Planned Change Notice Salt Disposal Investigations

Planned Change Request Repository Reconfiguration

DOE Proposed Panel Closure Redesign Planned Changed Request

Figure 1. Diagram of an Alcove and Heater for the SDI Test (1 of 5)

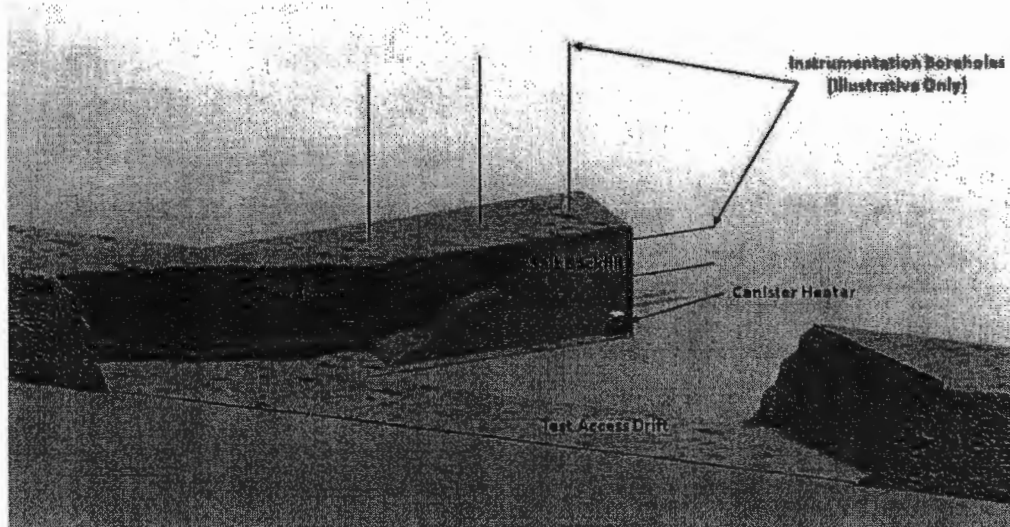
The primary goal of the SDI field test is to measure the properties and behavior of *in situ* salt in response to temperature in excess of 320°F. The preliminary planning for the SDI test uses five 8.5 kilowatt (kW) heaters in mined alcoves of a central pillar. The preliminary design envisions a two-year heating phase followed by an 18- to 24-month cool-down phase after the heaters are turned off. After the cool-down phase, personnel will reenter the test alcoves to perform additional testing on the halite adjacent to the heaters. Figure 1 is a diagram of a single alcove and heater. The alcove is partly filled with crushed salt generated by mining operations. No radiological material will be used during the field testing.

Figure 1

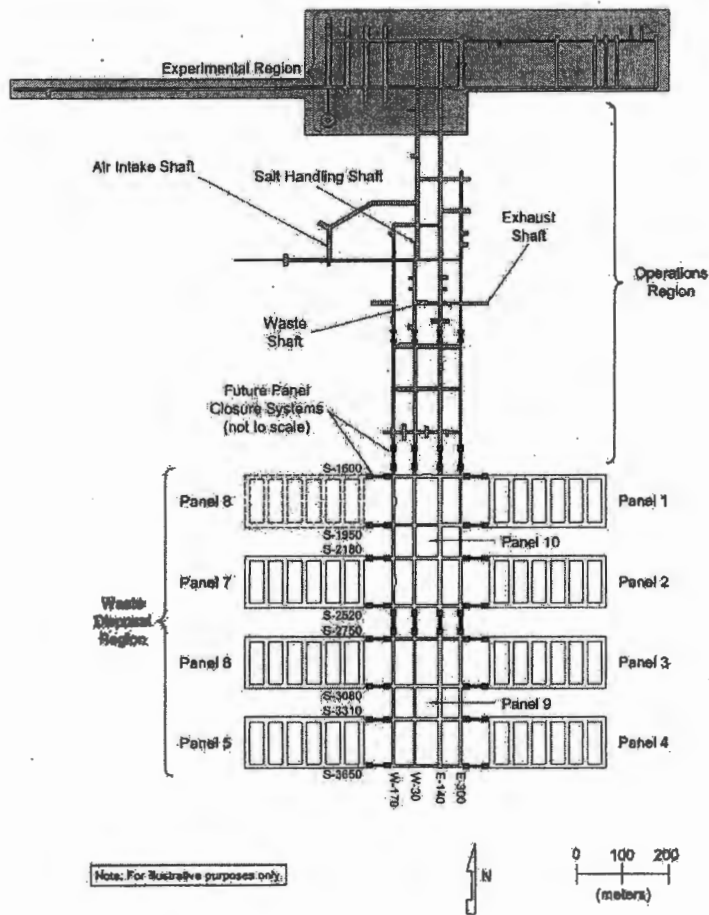
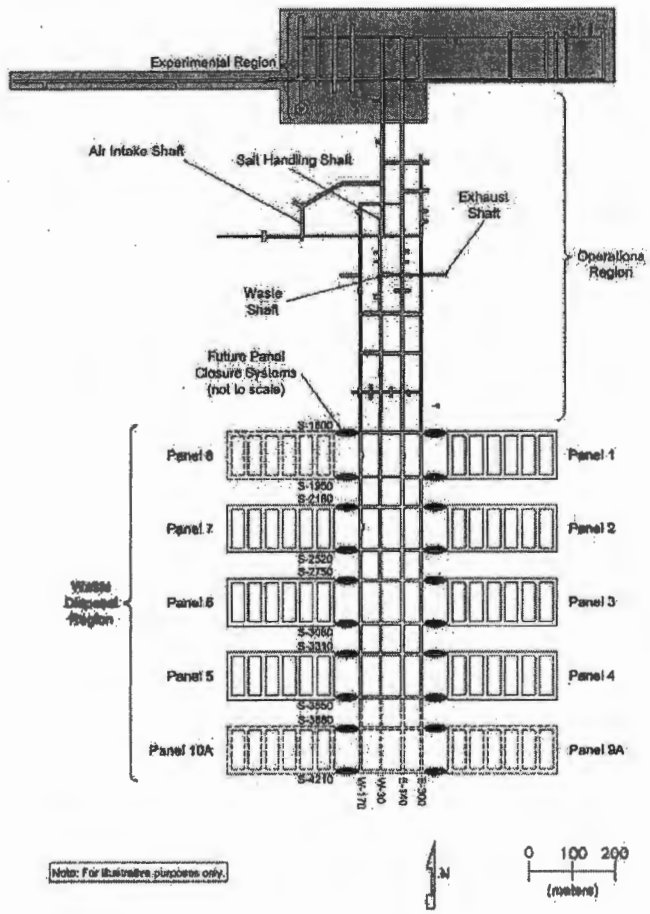
However, after years of mining and waste disposal activities, potential issues in the main access drifts and cross drifts have been identified. Due to the age of the access drifts and proximity of other mined waste panels higher rates of convergence and fracturing have been observed. Convergence is the movement or “creep” of the salt as it moves to fill voids created by mining. Fractures are separations or cracks in the salt that result from compression and tension stresses as the formation creeps. Observations have shown that widening areas, previously mined for daily functions other than waste disposal, can actually increase the salt creep rate from one to two inches per year to as high as five to seven inches per year. This has caused an increase in maintenance efforts in the form of trimming the floor, walls and roof (due to convergence) to established dimensions and installation of additional roof bolts and chain link mesh to control convergence and fractures and maintain safe conditions.

The DOE is proposing to modify the 40 CFR Part 191 Compliance Certification with a change in the current configuration to the WIPP underground repository. Due to the geotechnical issues and the extensive maintenance to existing, older sections of the WIPP underground, DOE is proposing to relocate Panels 9 and 10 from the existing north-south access drifts, south of the existing Panels 4 and 5, to mine what are being designated as Panels 9A and 10A (See Figure 2). Panels 9A and 10A will have the same dimensions as the previous eight panels. Relocating Panels 9 and 10 to the south of Panels 4 and 5 will enhance worker safety and reduce maintenance requirements by providing a more stable geotechnical environment for the two new waste panels.

Option D Design

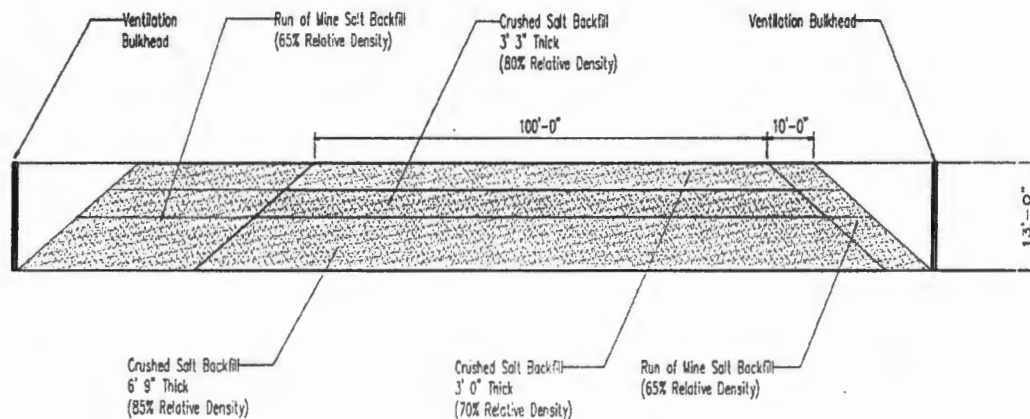
After the initial certification of the WIPP facility, the DOE initiated tests of SMC. SMC testing results showed that the material as specified in Condition 1 could not meet the performance requirements outlined in the Compliance Certification Application (CCA) Appendix Panel Closure System (PCS). In addition, closed panels were monitored for hydrogen and methane concentrations. Data collected after two and a half years of monitoring shows that neither methane nor hydrogen concentrations approach the lower explosive limits of these gases.

After 12 years of operations, the DOE found itself in a position to redesign a panel closure system to meet performance standards (as defined in CCA, Appendix PCS) and ensure it is less expensive and easier to install than the original Option D. The Run-Of-Mine (ROM) Panel Closure has two components: two bulkheads and a ROM salt backfill.

The construction methods and materials to be used in this design have been proven in mining and construction projects. In the base design two ventilation bulkheads will be used at either end. In those panels that already have a block wall bulkhead in place, the block wall will form one end of the closure, with a ventilation bulkhead used at the outer end after placement of the salt. The ROM salt backfill will be placed in contact with the salt surfaces of the drifts, including the back or roof. A variety of techniques are available for placing the ROM salt. The bulk of the salt can be placed using equipment already in use at the WIPP and flingers or blowers can be used for final placement against the back. The ROM salt will be placed until the entire drift is filled over a minimum distance of 100 feet. Over time, creep closure of the drifts will ensure that the salt backfill consolidates to a condition approaching intact salt with a low permeability. The fabrication, installation, and maintenance of bulkheads, such as those proposed for the closure, are standard at the WIPP facility.
